Sydney Olympic Park Master Plan 2030 (2016 Review) and State Significant Precincts SEPP Amendments

Feedback on selected elements from the Master Plan 2030.

North-South Line 1: Hurstville-Strathfield

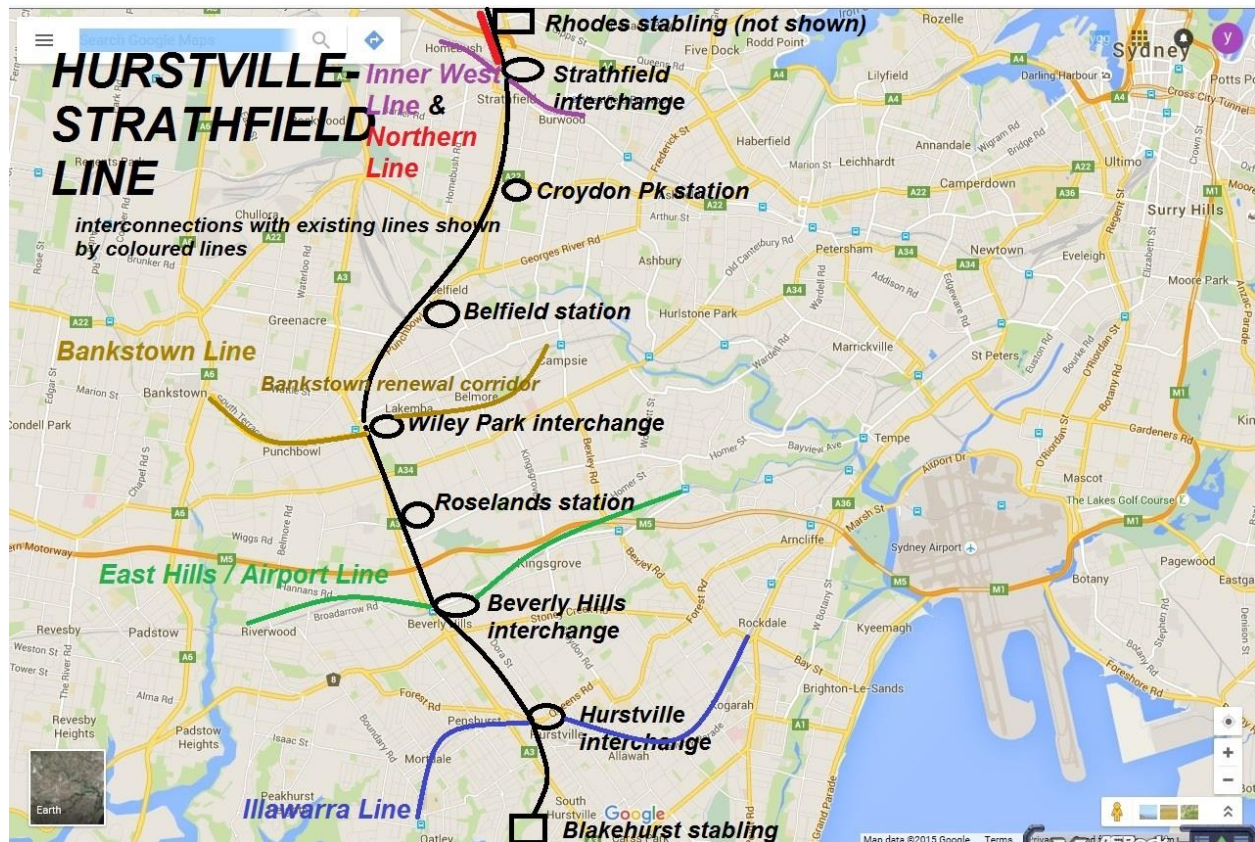
The remedy is to take the bull by the horns. North-south lines (more than one) need to be built across the 4 existing east-west lines that fan out from Central. That means building Hurstville – Strathfield (which could be done at low cost with value capture), a line which is essentially an extension of the Northern line south, and connecting the Illawarra, East Hills, Bankstown and Western Lines. This would also remove Northern Line trains from the intercity tracks heading into Central, thereby freeing these up for more East-West trains on the Western lines, currently close to capacity.

This means that residents in Olympic Park would be able to board the Sprint to Lidcombe, change and arrive at Strathfield where they could then proceed South directly. With a light rail linking SOP directly to Strathfield, a change over to the Hurstville-Strathfield line means that they could be at the Airport within 20 minutes, or in Bankstown, or Hurstville, or the South Coast / Illawarra in a very short period of time.

This would also avoid the disaster of having 30,000 people piling into Central/Redfern as the sole possible transition point in the network. It is asking too much of those already crowded stations to take on this number of people transitioning, and is a risky proposition to put all transitions across the network funnelled through a single point. If that point fails, the whole network fails. There is no redundancy built into such a system.

It is for that reason that Hurstville-Strathfield is an integral part of the Sydney Olympic proposal, given the understanding that residents will not only want to travel north and south, but also east and west on different parallel lines currently only accessible via Central / Redfern.

North-South Line 2: Olympic Park – Padstow - Menai

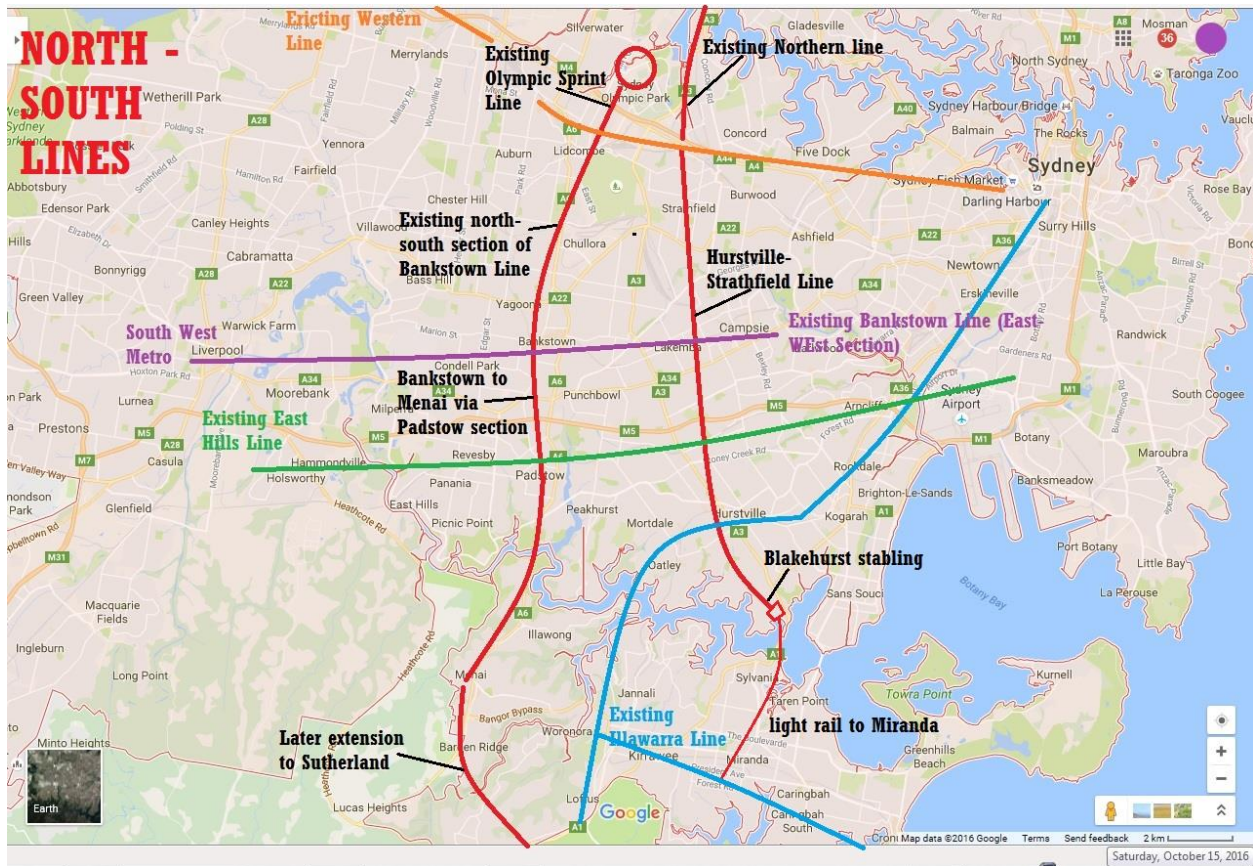
Another line could be built by connecting the existing Olympic Park Line with the north-south length of the Bankstown line, and then extending that further south to Padstow. This would then make a cross-link at the following passenger changeover nodes:

- the existing Western line at Lidcombe
- with the line at Chester Hill-Sefton-Regents Park (which itself could continue through Potts Hill eastwards) and
- with the new south west Metro that should then head to Liverpool and be a second line to the new Western Sydney Airport
- with the East Hills line at Padstow

The line could continue the line south towards Padstow, Padstow Heights, crossing the Georges River (over or under) to Menai, with a possible extension through to Sutherland. This should be a metro line.

The Hurstville – Strathfield and Olympic Park – Menai line would not only service Sydney Olympic Park, allowing masses of people to travel across the network without having to all pile in via Redfern and Central (a dangerous reliance upon a single node to carry the entire network) and create a game changer for the middle ring of Sydney out to 20km from the CBD, forming a genuine ‘network’ or grid formation of east-west lines junctioning with north-south lines, that permitted travel across the entire metropolis. This would result in the removal of massive amounts of traffic off the roads – particularly the gridlocked A3 and A6, for which Westconnex will not be a solution - and allowing for a corresponding increase in density along all rail corridors while retaining all green spaces in the suburbs concerned.
